# Brent Decommissioning Derogation: An evaluation

**The Ministry of Infrastructure and Water Management  
Government of The Netherlands**

**an independent evaluation group**

4 October 2019

Page 22: Figure 7 shows the general arrangement of drawdown system and the piping system that goes into the cells (see also Figure 10).

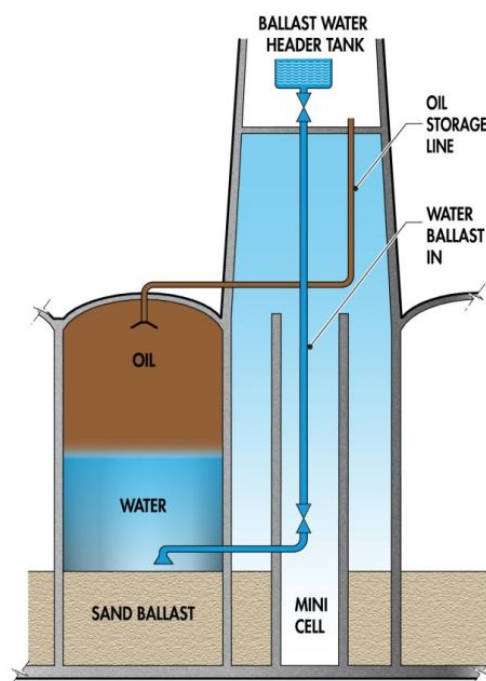
Page 46: The estimated volume of the cell sediment is uncertain due to the incompleteness of the production history (only data from the last 10 years of production) and the lack of measurements of the sand concentration in the produced fluids.
